Reference: Beaver Valley Power Station, Unit No. 1
Docket No. 50-334, License No. DPR-66
IE Bulletin 80-11

This letter forwards the additional information for IE Bulletin 80-11, "Masonry Wall Design" as requested by your letter dated March 23, 1982.

Beaver Valley Power Station - Unit 1

The following is provided as the response to the NRC request for additional information dated March 23, 1982. This report provides a reprint of each of the seven (7) staff questions with the applicable response following the question.

1 2 3 4 5 6 7 8 9 10 11 12 13 14 15 16 17 18 19 20 21 22 23 24 25 26 27 28 29 30 31 32 33 34 35 36 37 38 39 40 41 42 43 44 45 46 47 48 49 50 51 52 53 54 55 56 57 58 59 60 61 62 63 64 65 66 67 68 69 70 71 72 73 74 75 76 77 78 79 80 81 82 83 84 85 86 87 88 89 90 91 92 93 94 95 96 97 98 99 100

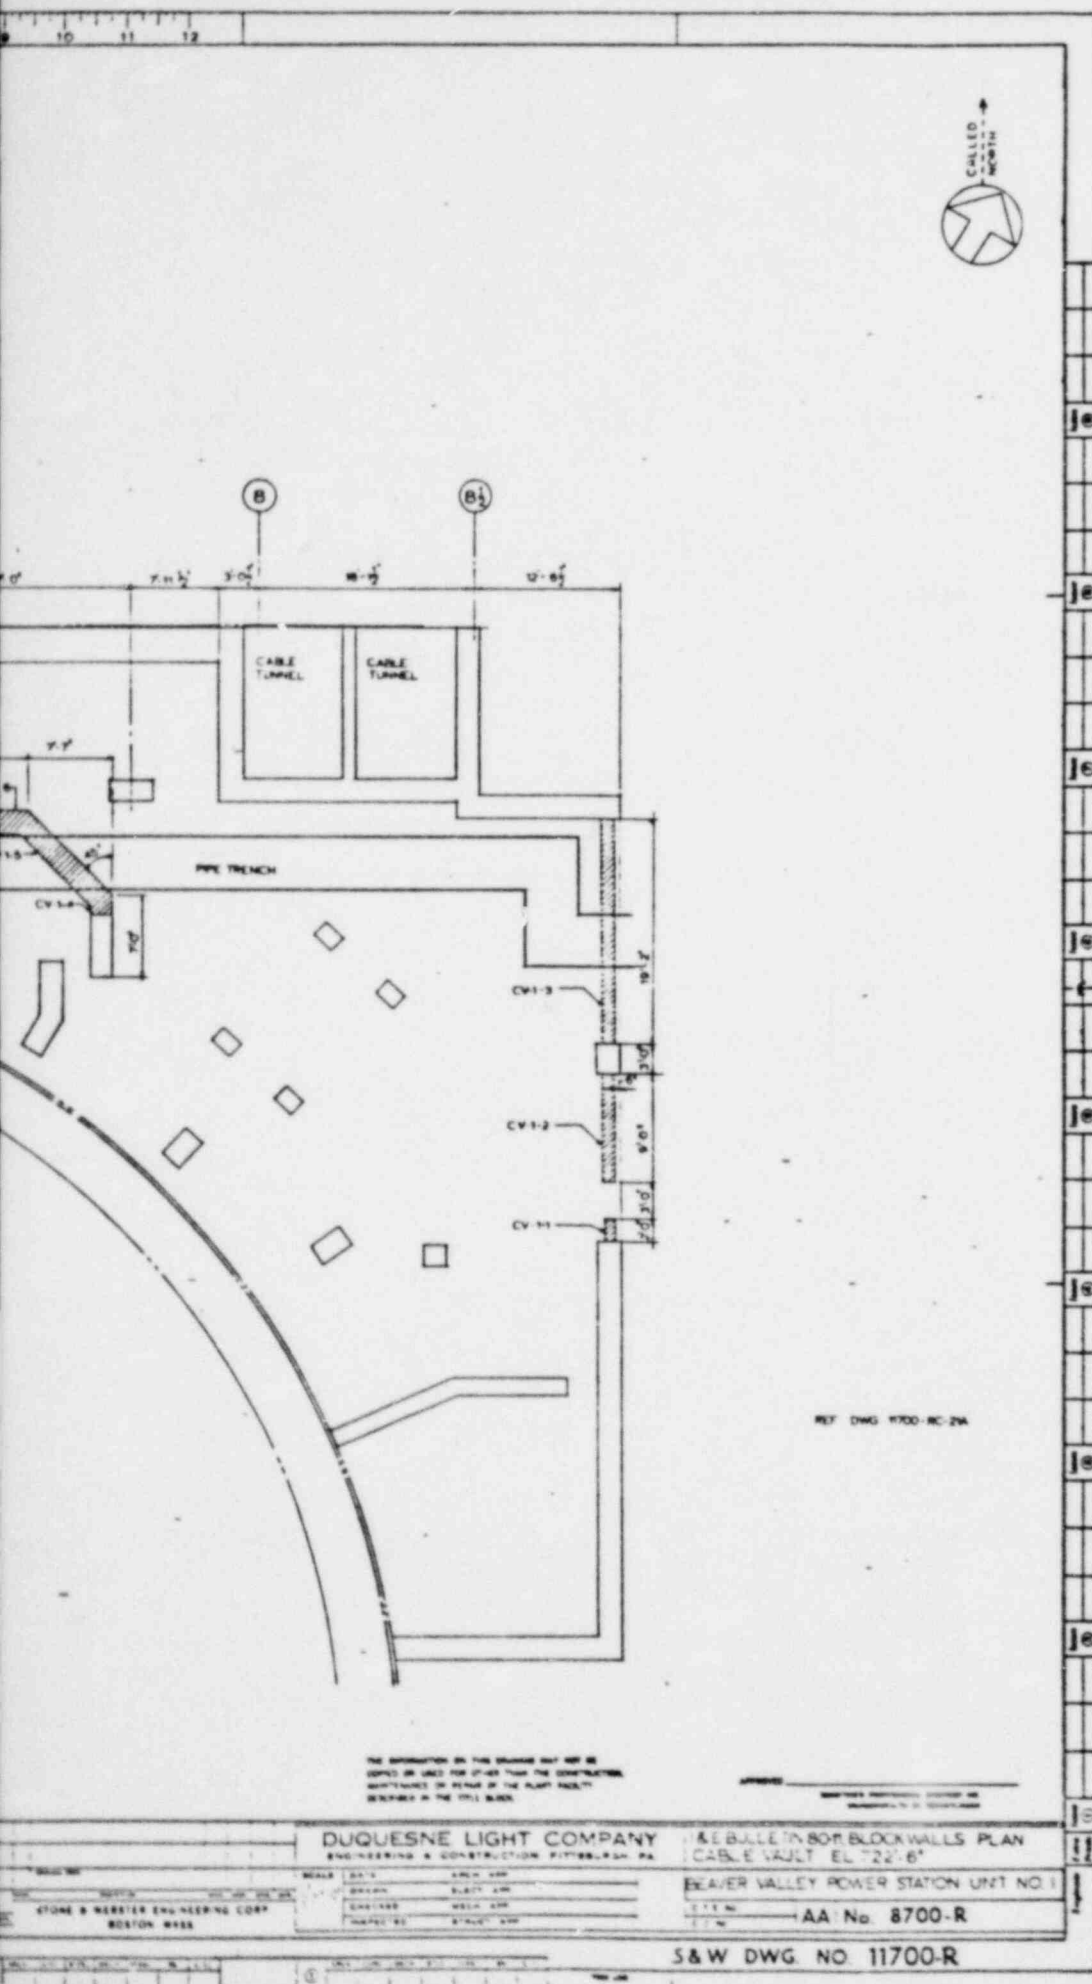
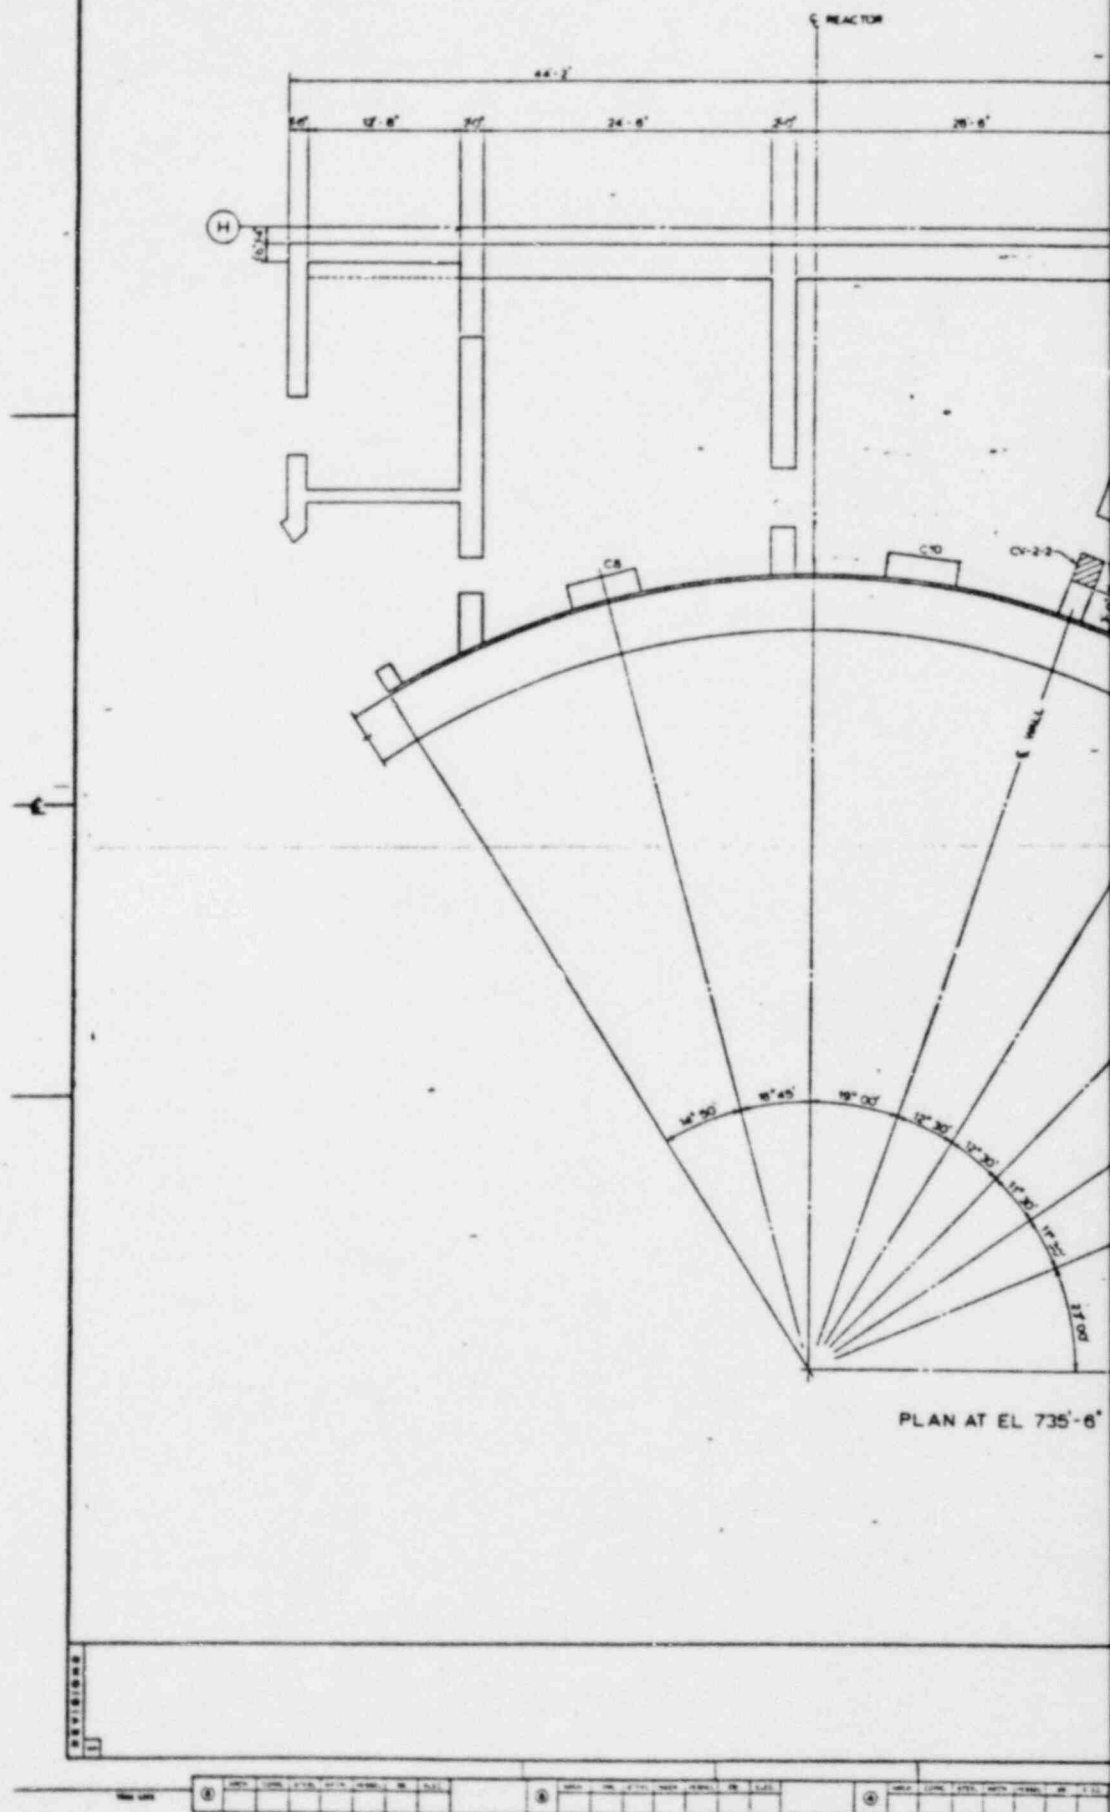
6. Provide legible copies of drawings indicating the locations of safety-related masonry walls in the auxiliary building, cable vault, fuel and decontamination building, and service building of Beaver Valley Power Station Unit 1. Location plans for auxiliary building masonry walls included in Attachment A of Reference 3 are not legible.
